| Topic | GT V8T GTC V8T HVAC refrigeration pipe - clip replacement - Corrosion (SC13/20) |
| Campaign number | E797 |

Workshop Campaign E797

GT V8T GTC V8T HVAC refrigeration pipe - clip replacement - Corrosion
(SC13/20)

Figure 1

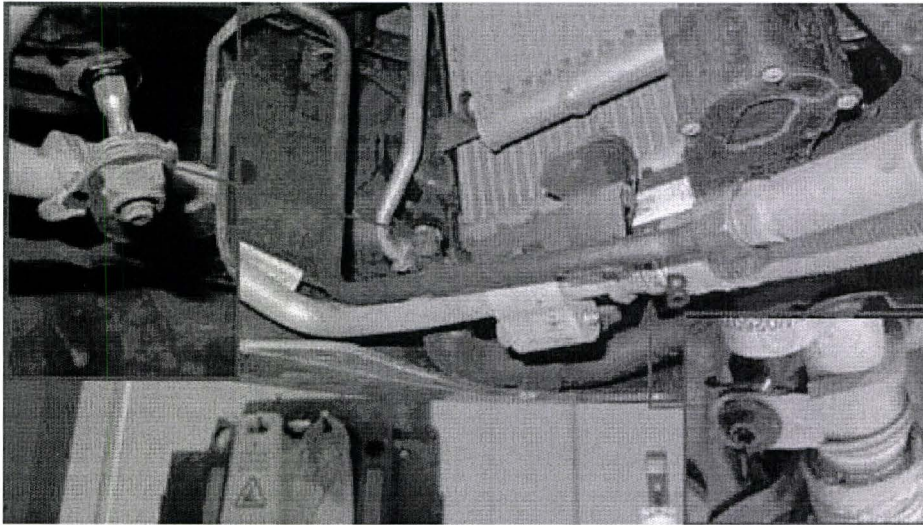
5. Referencing figure 1 identify the two 'P' clips (A and B) located in the front left hand wheel arch that require replacement
6. **Note:** A number of later cars in this campaign are expected to already have the correct clips fitted, figure 1 depicts the correct clips identified by a red band printed on the clip insert. Pipes fitted with clips carrying the red band do not required inspection and therefore will not require clip replacement.
7. Using a T30 bit loaded into a ratchet spanner remove the fastener securing P clip (A). Remove and discard clip A (see Figure 1)
8. Remove and discard clip B (see Figure 1)

Clips that do not promote this type of corrosion are now specified. The procedure details the pipe inspection and if required the corrective action necessary before fitting the two replacement clips

Figure 2

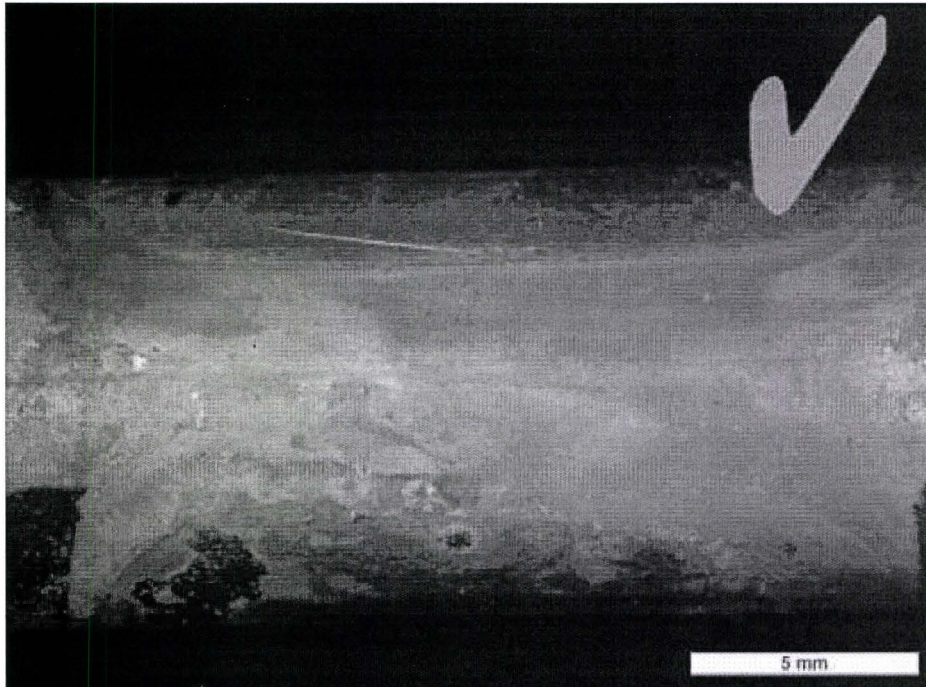
9. The two locations from which the clips have been removed should now be inspected for surface corrosion, a mirror may aid inspection. Discolouration and light oxidation on the surface of the pipe is not detrimental and does not necessitate pipe replacement (see Figure 2). If the pipe surface shows signs of extensive corrosion and pitting (see Figure 3) then that pipe should be replaced
10. On cars where the pipe is serviceable, figure 2, fit two replacement clips. For position A fit new clip part number RSGUV1.10-15W1, in position B fit new clip part number RSGUV1.18-15W1. If either

pipe is found to have extensive corrosion then both pipes should be replaced before replacing the clips, in this case follow the Air conditioning pipe replacement procedure detailed below.

Figure 4

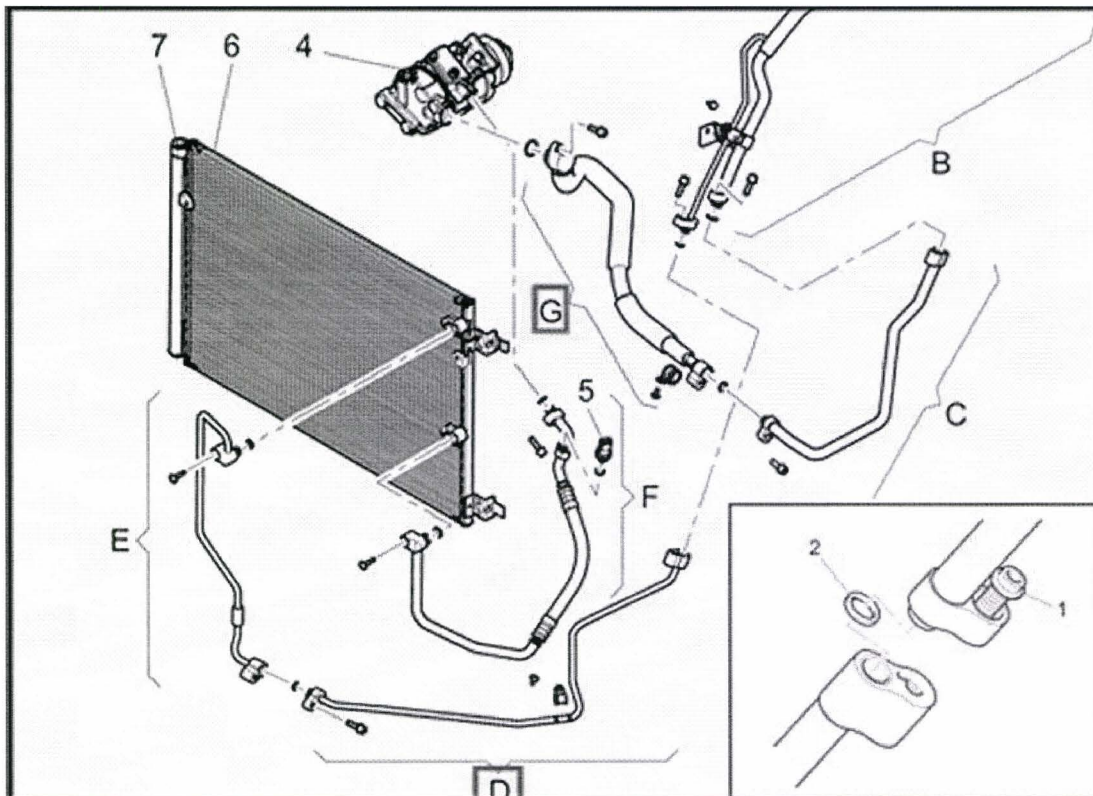
4. Locate and replace pipe G and D (see Figure 4). Refer to workshop manual Rep. Gr.87 Refrigeration pipes and hoses – To remove and fit
5. Fit and secure the pipes using the two new pipe clips
6. Evacuate, recharge and leak test the refrigerant system Rep.Gr.87 Refrigeration system – To discharge and charge
7. Apply yellow paint campaign identification mark to the air conditioning suction pipe (see Figure 5)
8. Refit the front wheel arch liner Rep. Gr.66 Front wheel arch liners- To Remove and Fit
9. Refit the front undersheet Rep. Gr.66 Front undersheets – To Remove and Fit
 - The vehicle can be taken out of "Jack mode". Simultaneously press and hold down the ride height and damper setting buttons located on the lower centre console for five seconds until the self-levelling warning indicator is extinguished in the drivers instrument panel

Figure 5

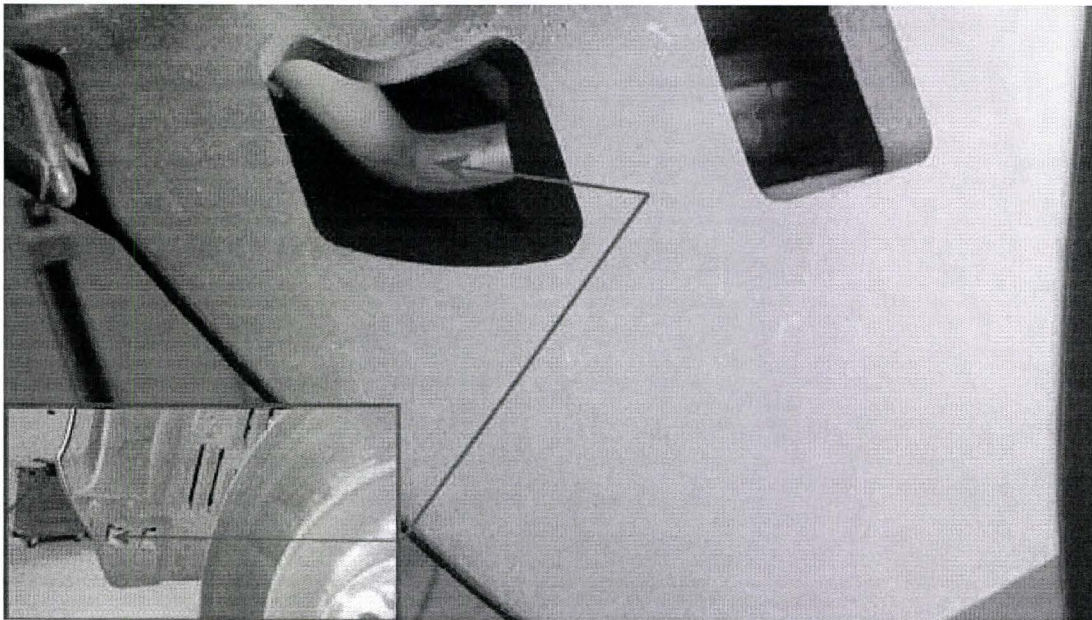
On completion apply a yellow campaign completion mark to the air conditioning suction pipe (large) such that the mark can be viewed through the left hand front wheel arch liner (see Figure 5)
